**TOWN OF TUNNELTON MUNICIPAL SEWER WORKS
PRESTON COUNTY, WEST VIRGINIA**

**PHASE II – 0.04 MGD WASTEWATER TREATMENT PLANT AND COLLECTION
SYSTEM UPGRADES**

ADDENDUM #1

AUGUST 24th, 2022

LAYOUT TAB: 22
 CAD FILE: R:\020\020-10033 Tunnelton Sanitary Board - WWTP Improvements\Drawing\Plan Set\007-MH REHAB Plans.dwg
 PLOT DATE/TIME: 8/24/2022 11:49 AM
 USER: andrew sayre

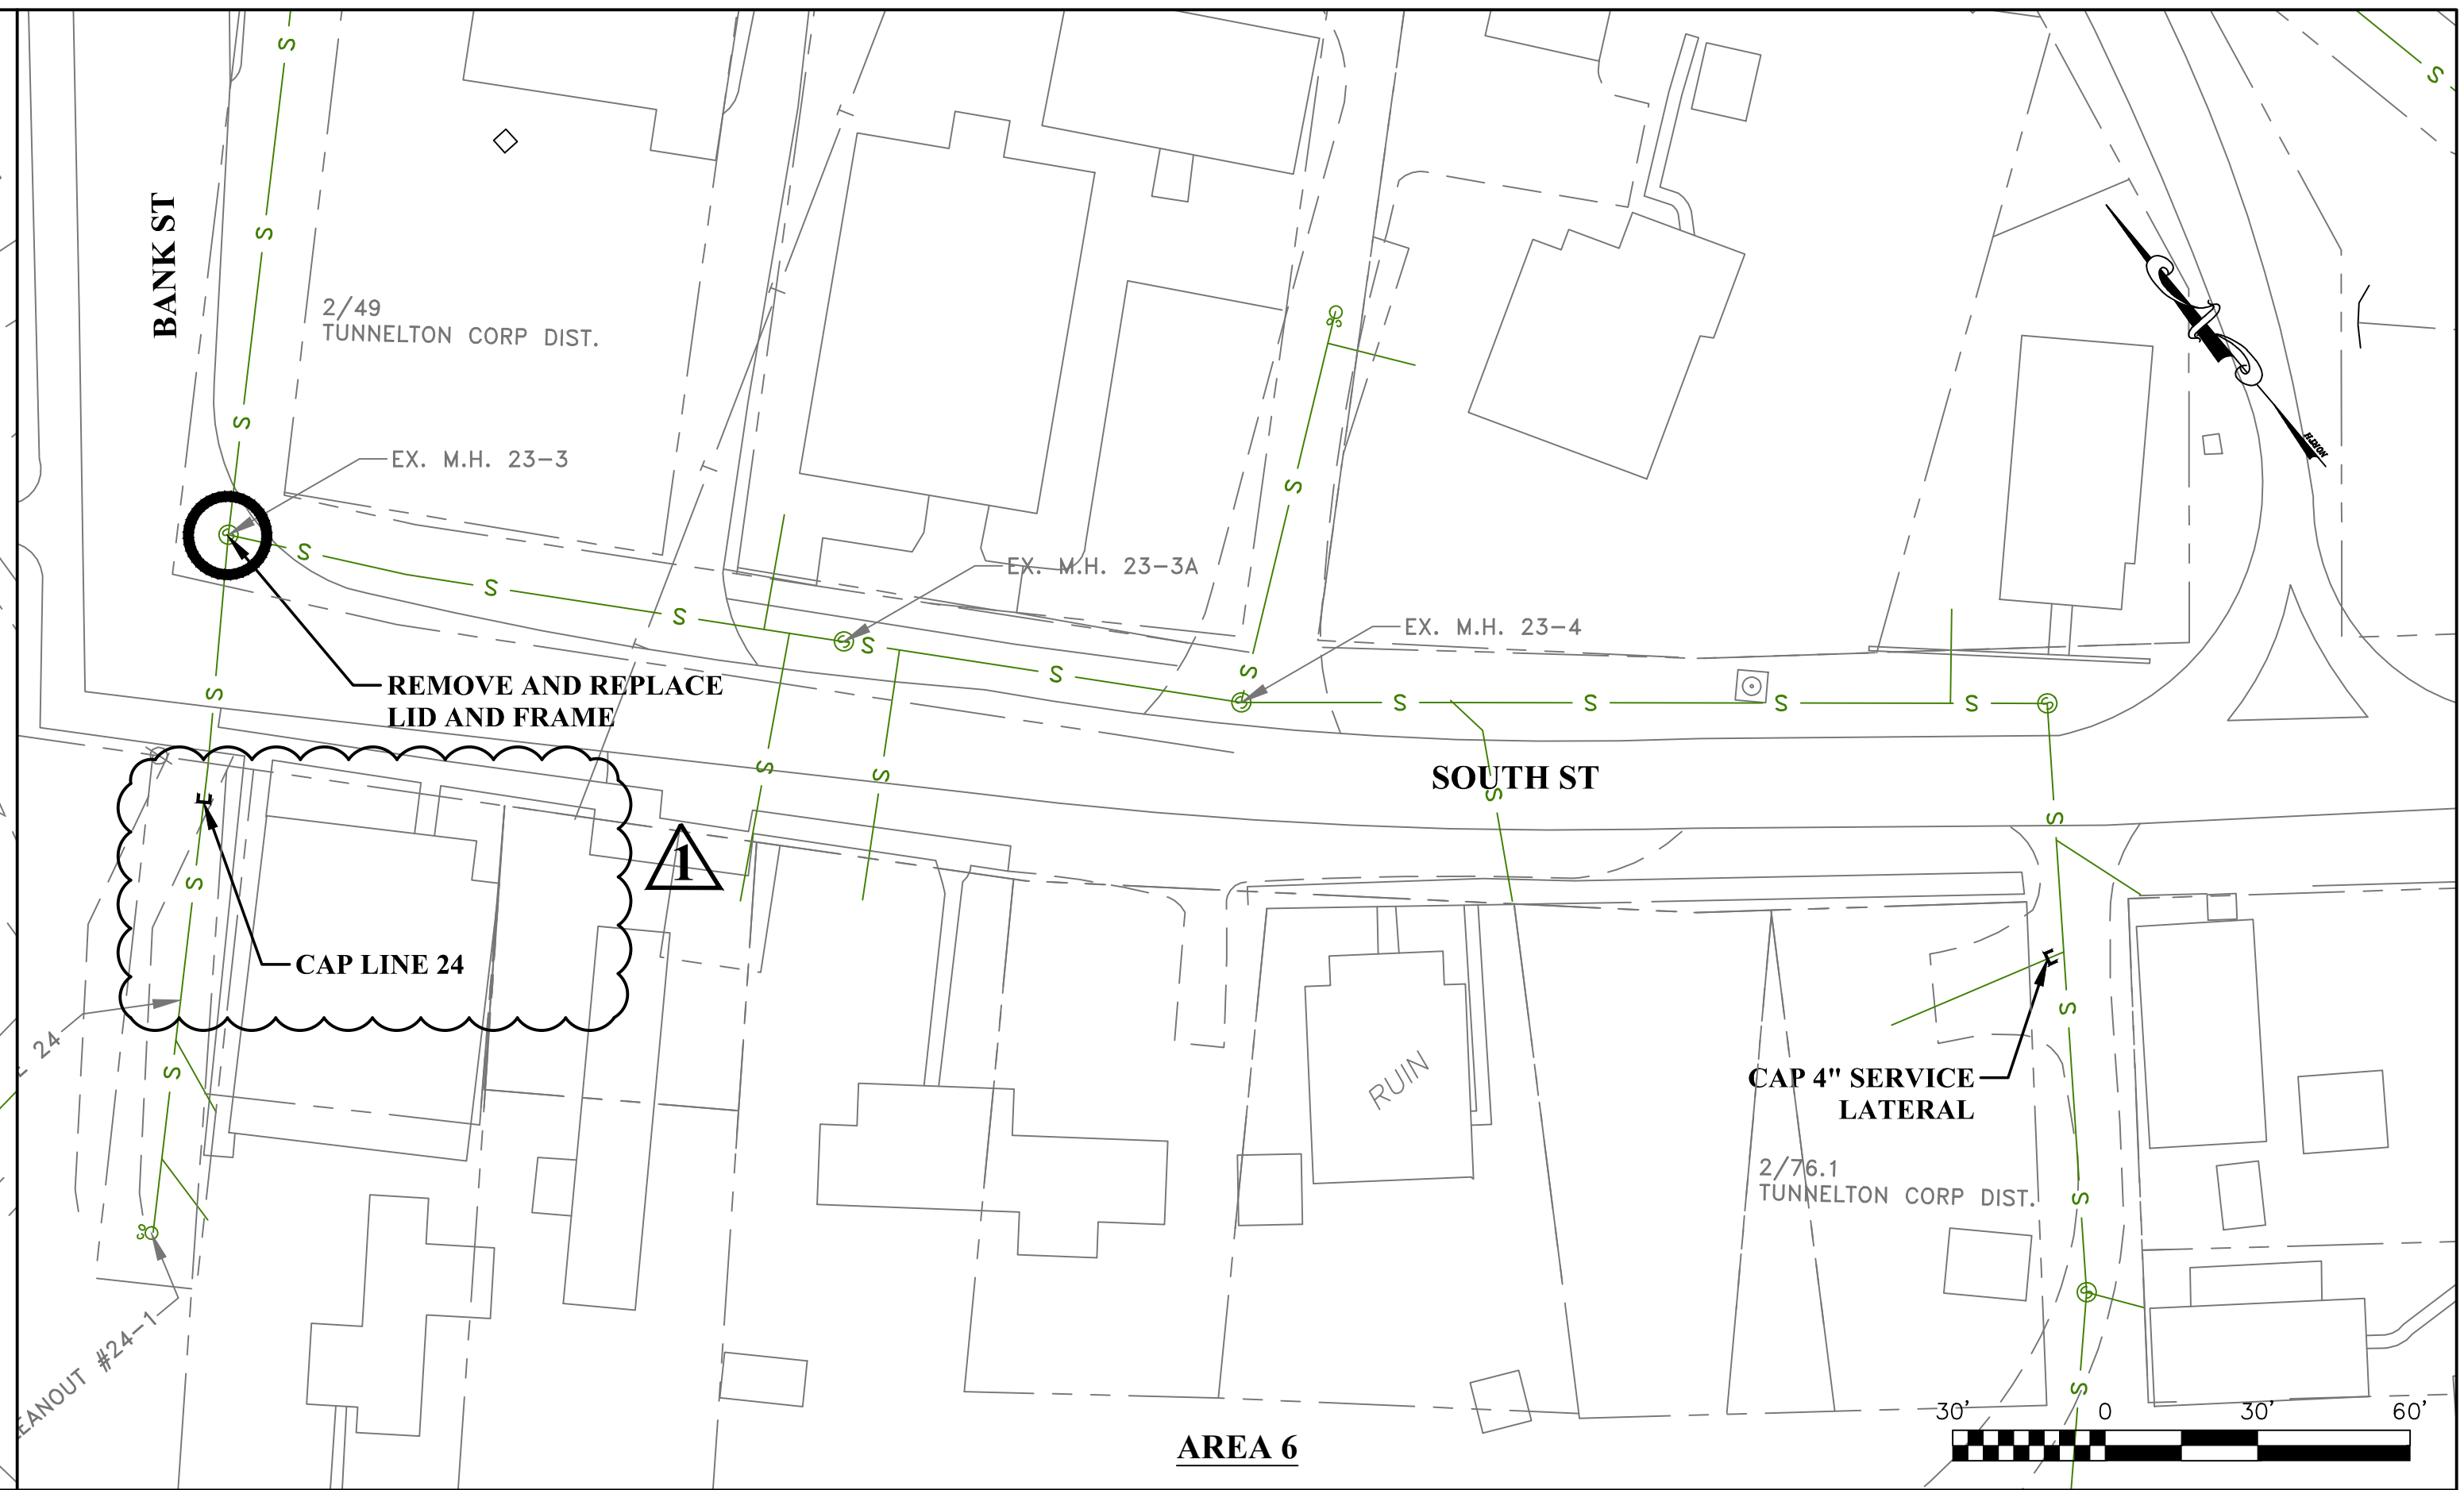
5. Sheet 22 indicated that line 24 of Area 6 is to be capped. This is shown in the middle of the roadway. Can the invert of line 24 be plugged inside the downstream manhole or can the capping indicated be performed closer to Manhole #23-3? Also, what is the depth of the sewer lines to be capped?

Line 24 is to be capped to the south of South St. along the alignment. The line depth at this location is approximately eight feet. Plan Sheet 22 has been revised as part of this Addendum.
